DEPARTMENT OF THE ARMY
WILMINGTON DISTRICT, CORPS OF ENGINEERS
69 DARLINGTON AVENUE
WILMINGTON, NORTH CAROLINA 28403-1343

Action ID. SAW-2009-00556
NC DOT TIP No.: I-5111/I-4739

Subject: MODIFICATION of 401 Water Quality Certification Pursuant to Section 401 of the Federal Clean Water Act and NEUSE BUFFER RULES, with ADDITIONAL CONDITIONS for Proposed widening of I-40 from I-440 to SR 1525 plus improvements to NC 42 and SR 1010 in Wake and Johnston Counties; Federal Aid Project No. IMNHF-040-4(139)301; State Project No. 42346.3.1; TIP Nos. I-5111 & I-4739. NCDWR Project No. 20190593 ver 7.

PROJECT REFERENCE NO.	SHEET NO.
1-5111/1-4739	49
R/W SHEET NO.	
ROADWAY DESIGN ENGINEER	HYDRAULICS ENGINEER
INCOMPLETE PLANS DO NOT USE FOR R/W ACQUISITION	
DOCUMENT NOT CONSIDERED FINAL UNLESS ALL SIGNATURES COMPLETED

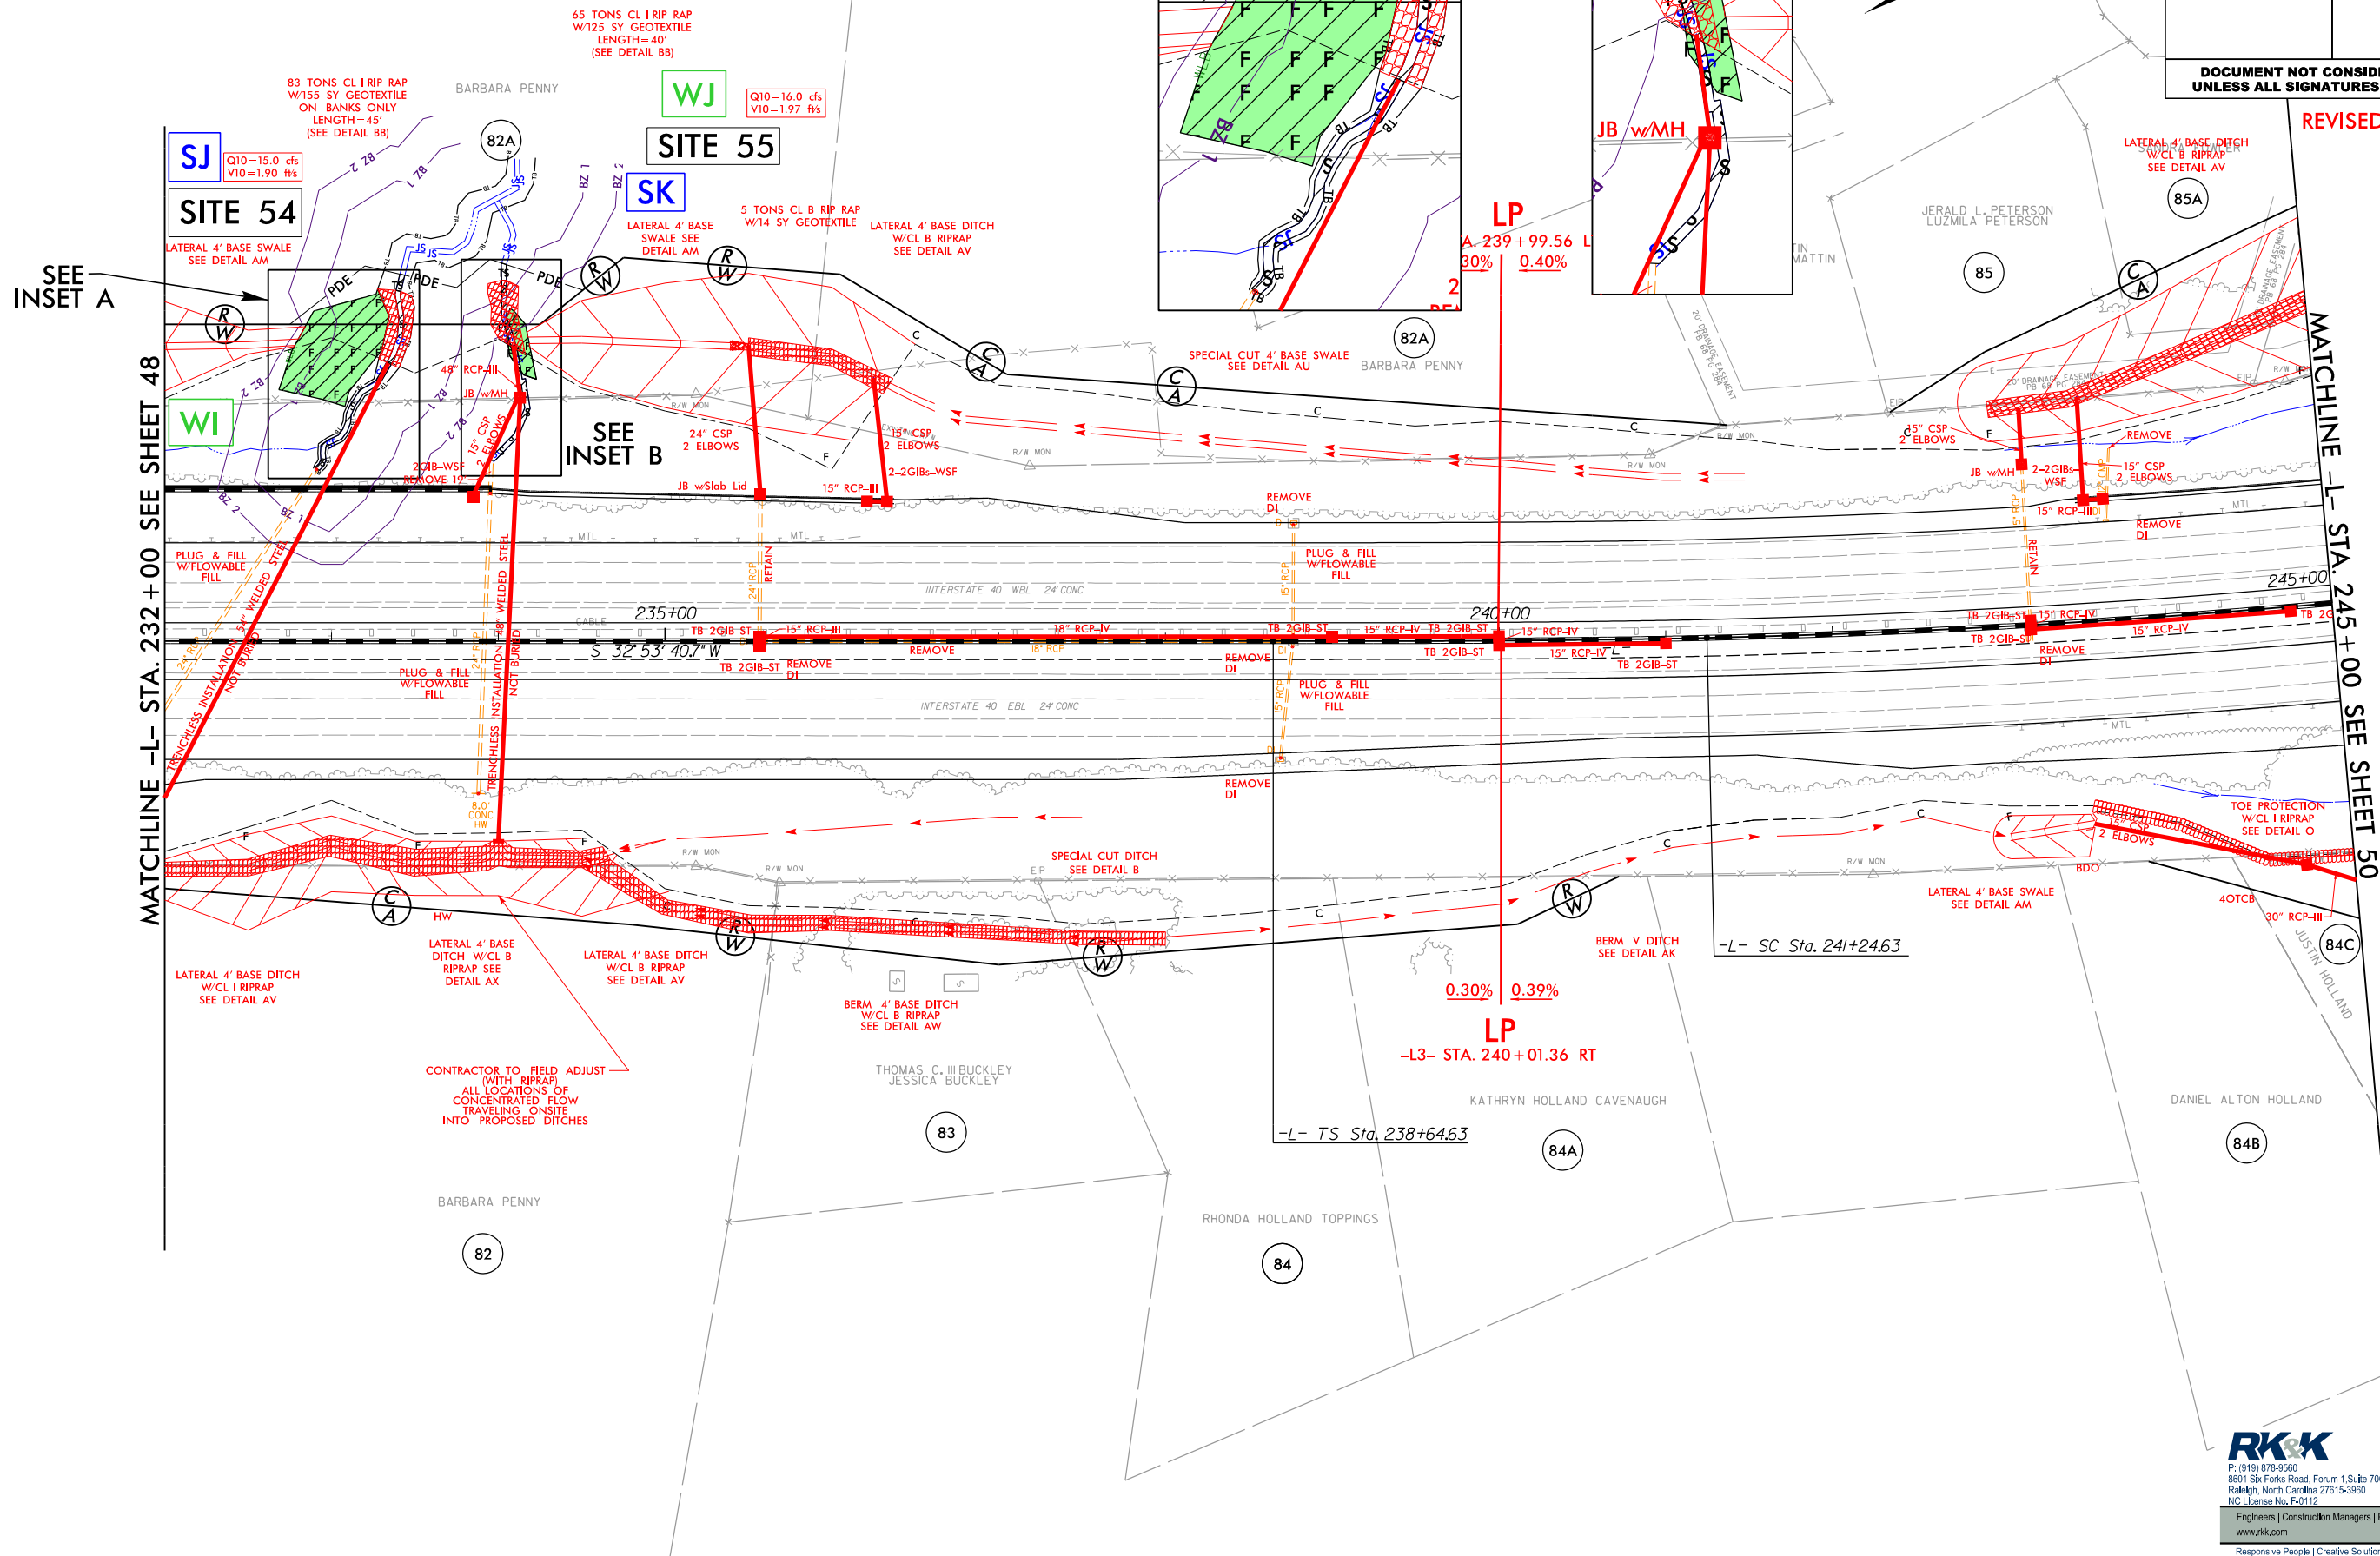
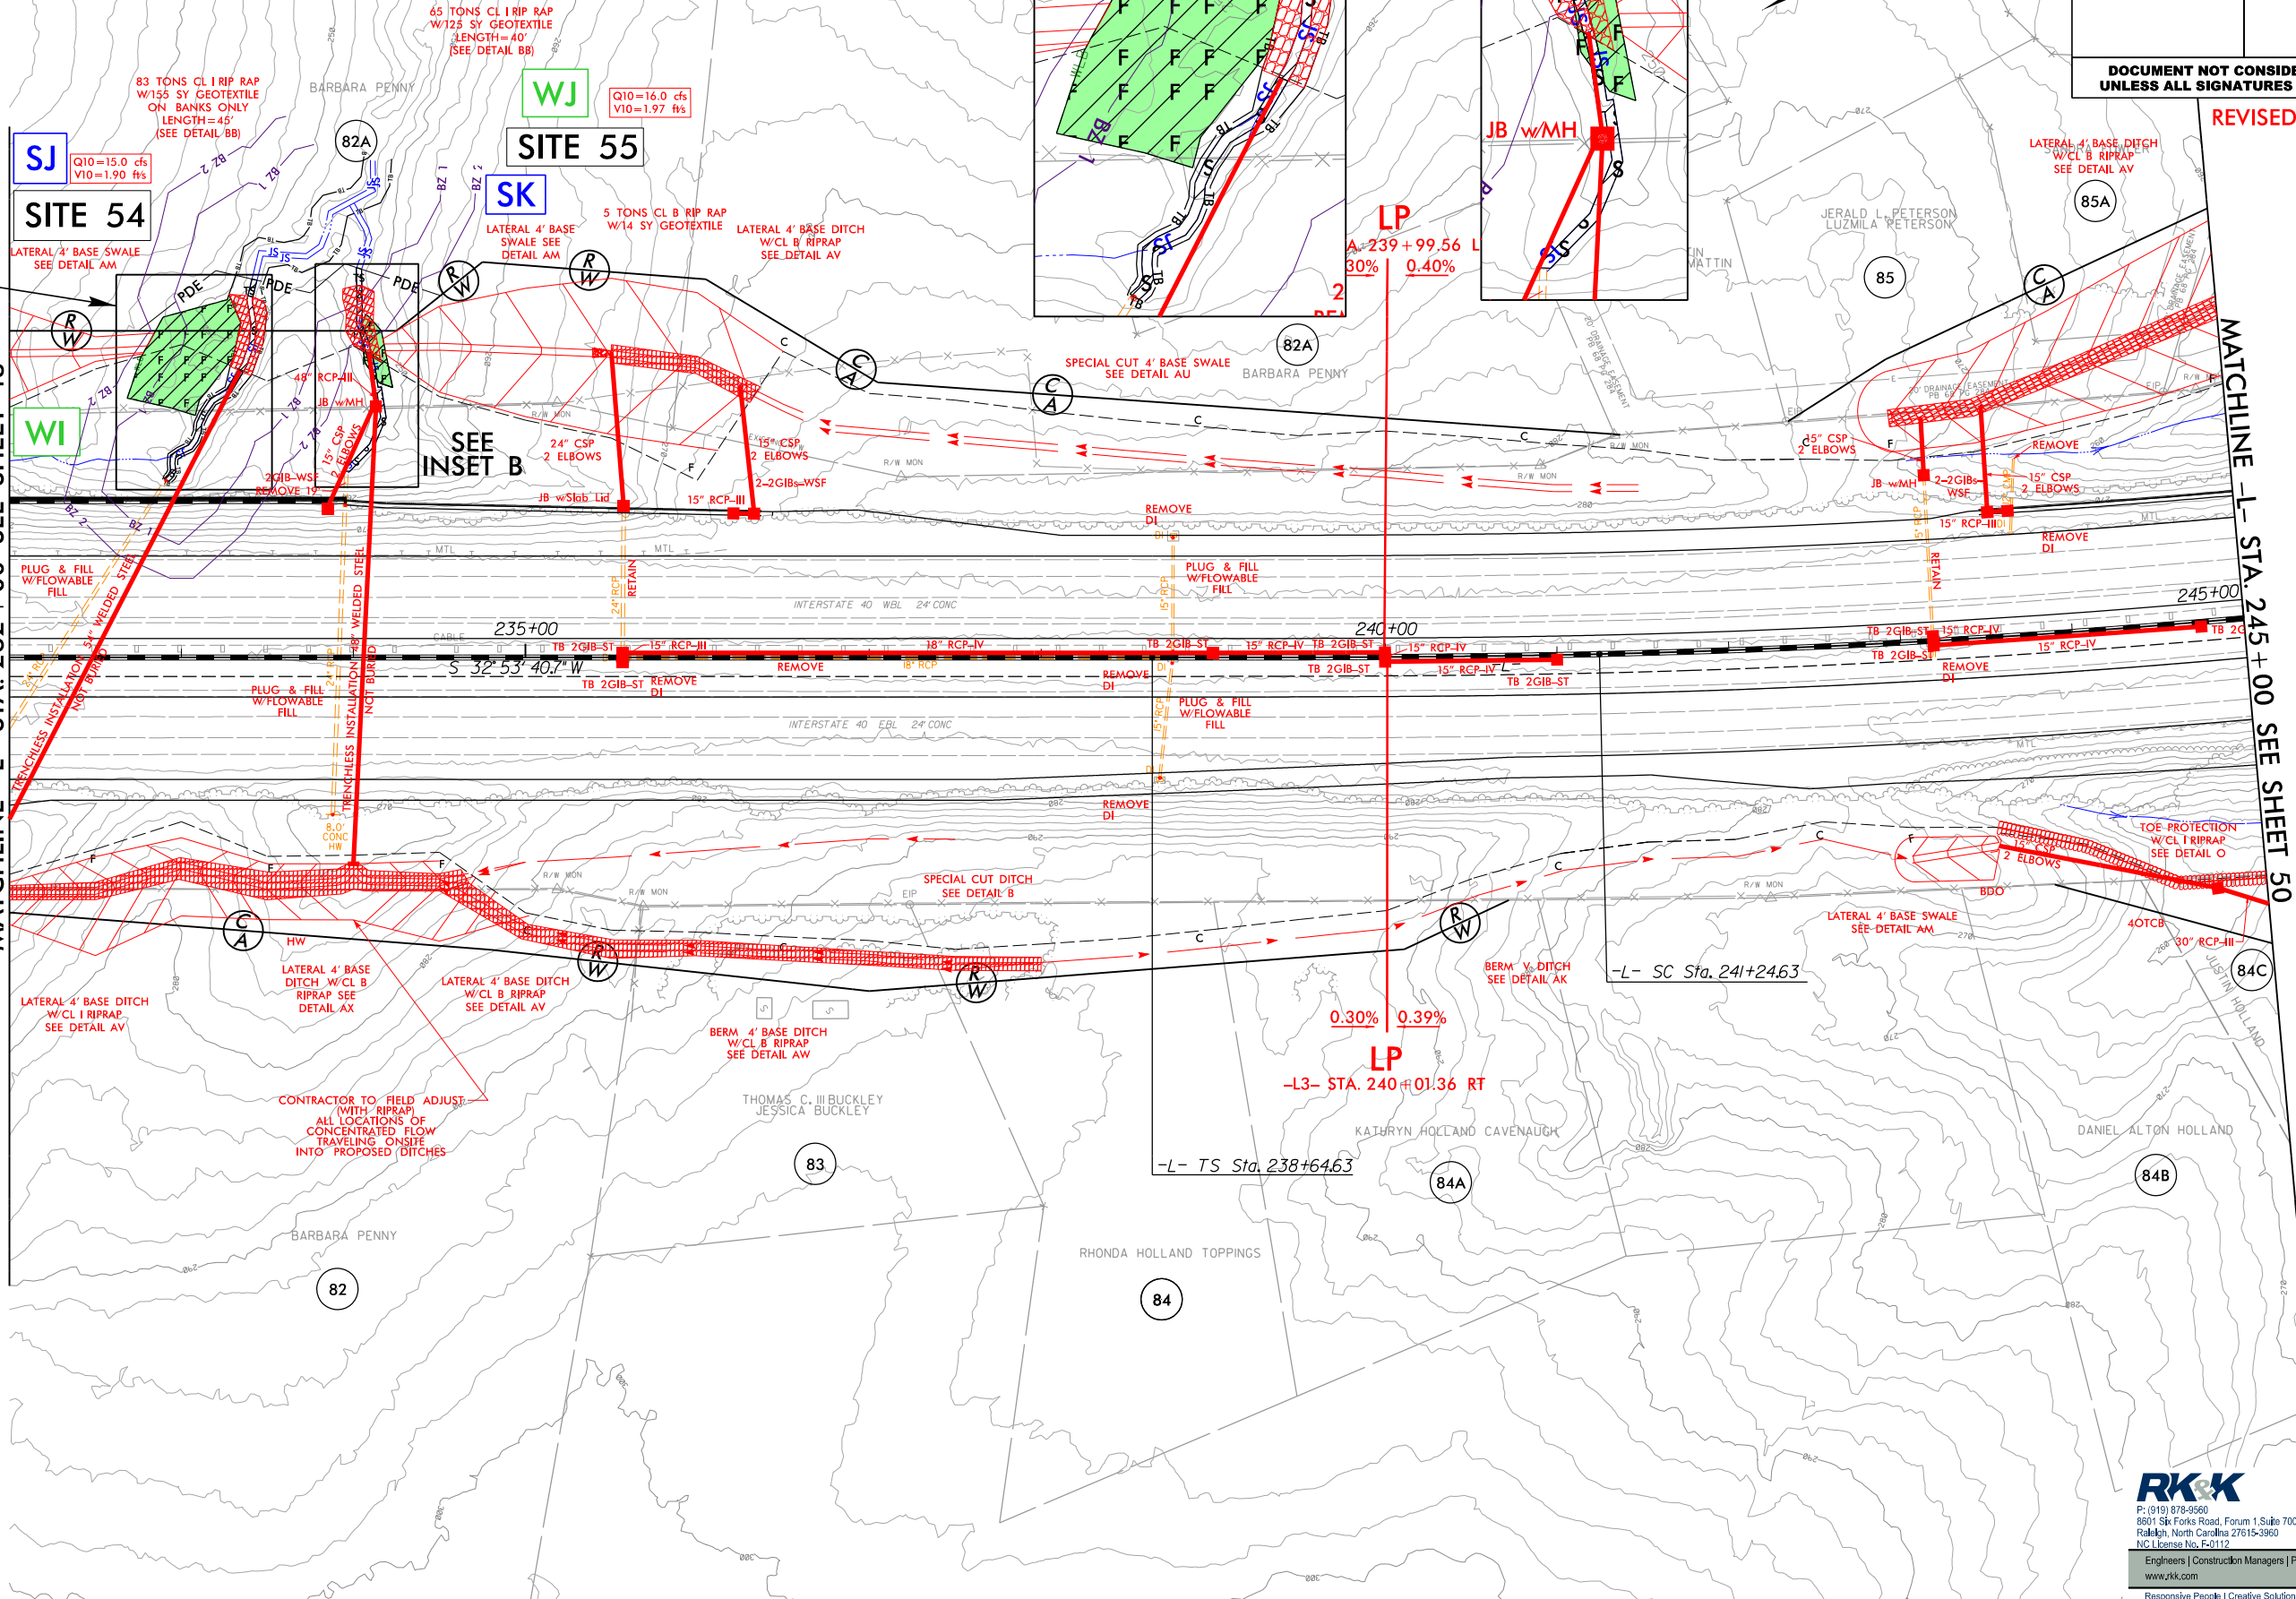
Site 55: Due to repeating erosion events and the general instability of the channel below the outlet, rip rap would be added to the flow line to match the length of the previously permitted bank stabilization.

- 40 linear feet decrease in bank stabilization impacts
- 40 linear feet increase in permanent stream impacts

Site 55:

- **+40 linear feet Stabilization permanent impact to Perennial Stream**
 - **-40 linear feet (decrease) Temporary Perennial Stream impact**
- *Site 55 revised totals in application plan sheets July 6, 2022: 118 linear feet Permanent Stream Impact. 10 linear feet Temporary impact. 0.01 ac wetland impact. No buffer impact.*

The authorized work shall be completed in accordance with the attached revised permit drawings sheets 17 and 49 of 125 submitted on July 6, 2022, and the Wetland and Surface Water Impact Summary Sheets 122 and 125 of 125 submitted on July 6, 2022. As there are an additional 40 linear feet of permanent stream impacts, compensatory mitigation is required at a 2:1 ratio for the permanent stream impacts associated with this modification. As proposed in the modification request, compensatory mitigation must be completed by debiting an additional 80 linear feet of compensatory stream mitigation credits from the official ledger for NCDOT's Marks Creek Mitigation Site in Wake County.

BUFFER DRAWING
SHEET 15 OF 52

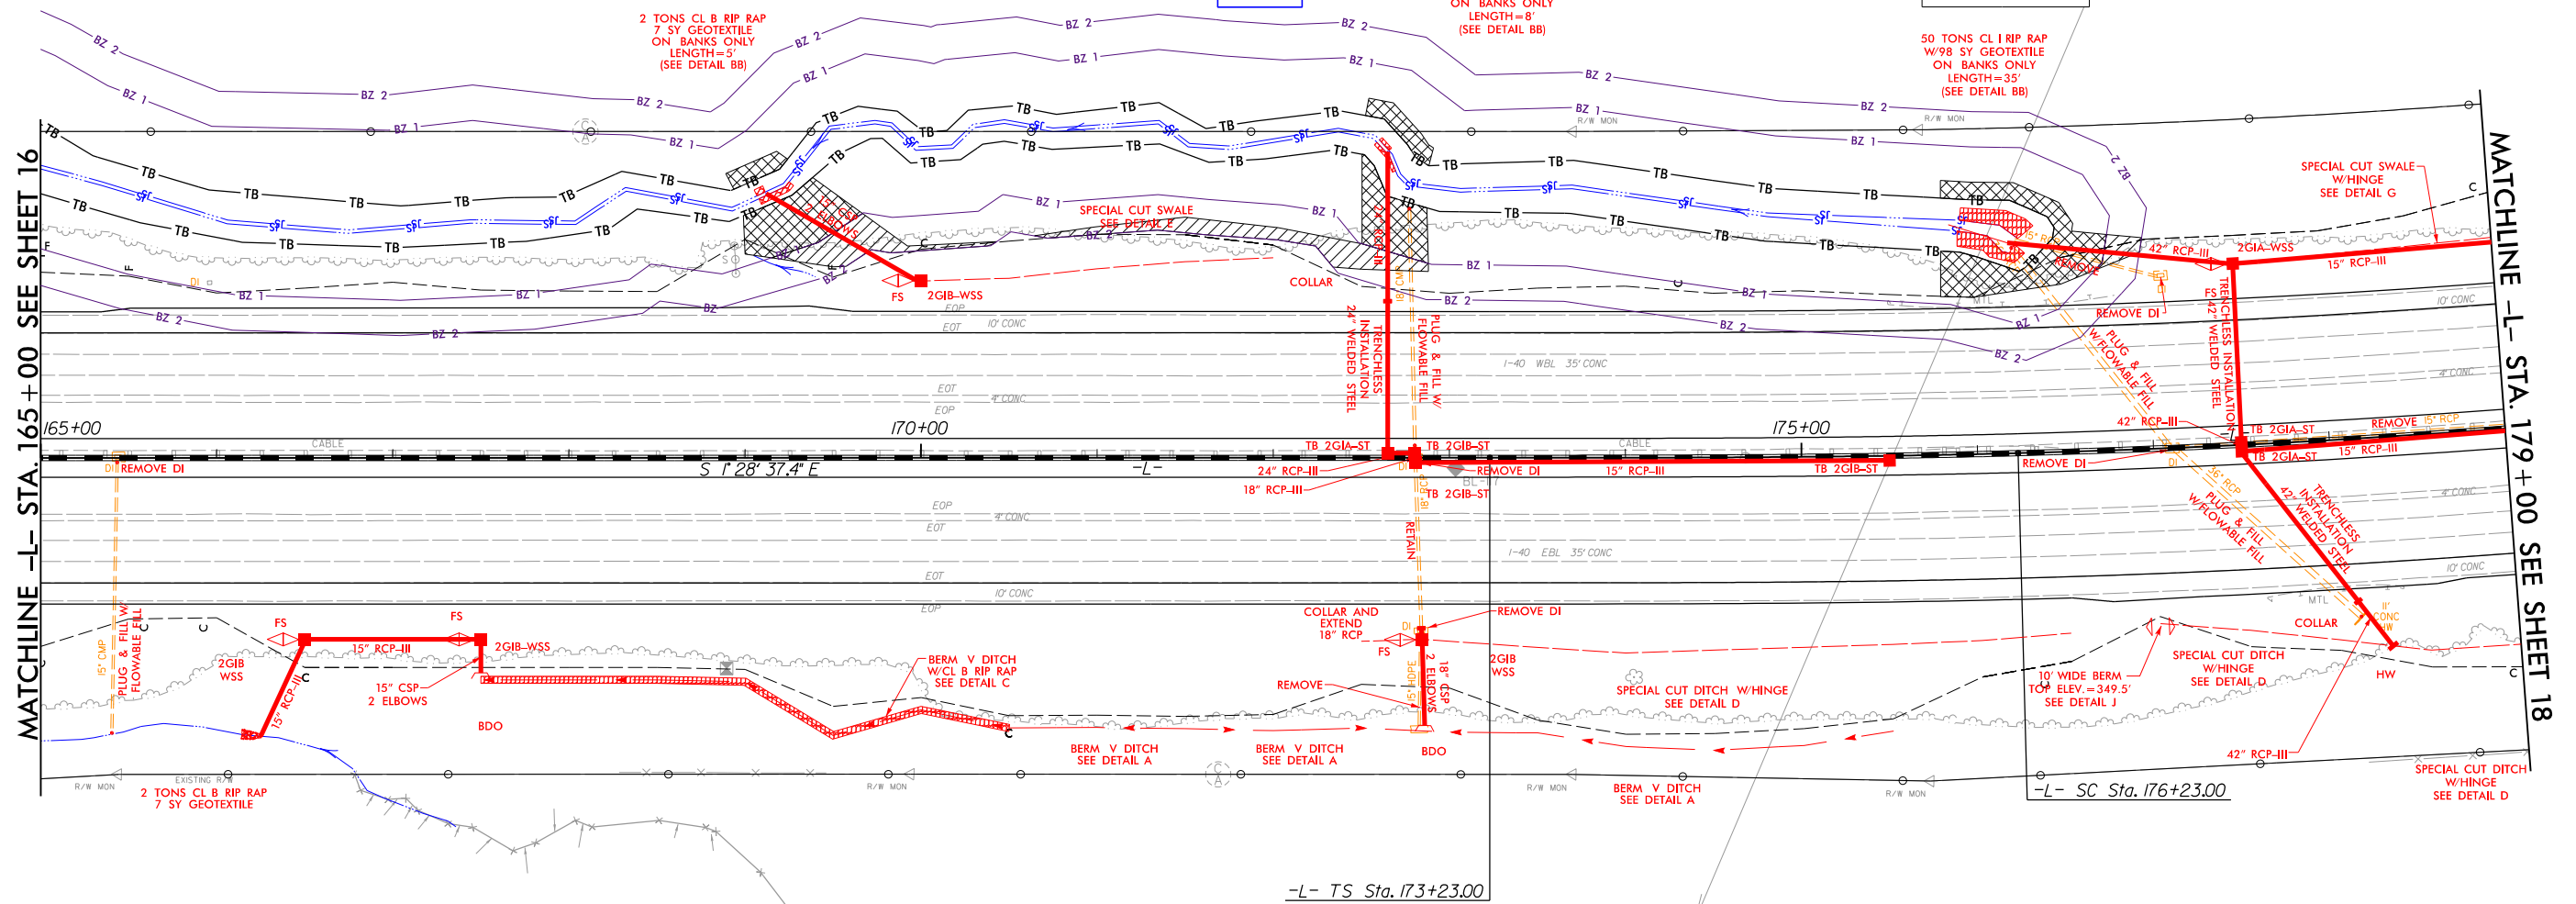
- **+15 linear feet Stabilization permanent impact to Intermittent Stream**
 - **+400 square feet Zone 1 Buffer Mitigable Impact**
 - **+186 square feet Zone 2 Buffer Mitigable Impact**
- *Site 14A revised totals in application plan sheets July 6, 2022: 20 linear feet Permanent Stream Impact. 20 linear feet Temporary Stream Impact. 0 ac wetland impact. 2058 square feet Zone 1 Mitigable Buffer Impact. 1132 square feet Zone 2 Mitigable Buffer Impact.*

1. Compensatory mitigation for impacts to 400 square feet of protected riparian buffers in Zone 1 (3:1 ratio) and 186 square feet of protected riparian buffers in Zone 2 (1.5:1 ratio) shall be required. We understand that you have chosen to perform compensatory mitigation for impacts to protected buffers through use of the Marks Creek Mitigation Site. Mitigation for unavoidable impacts to Neuse Riparian Buffers shall be provided via deduction of 1479 square feet of Buffer Restoration Credits at the Marks Creek Mitigation Site in accordance with 15A NCAC 2B.0295, as stated in your application and the included debit ledger.
2. All conditions in previous versions of this Certification dated July 10, 2019, September 4, 2019, January 22, 2020, June 3, 2020, September 16, 2020, and January 26, 2022 still apply.
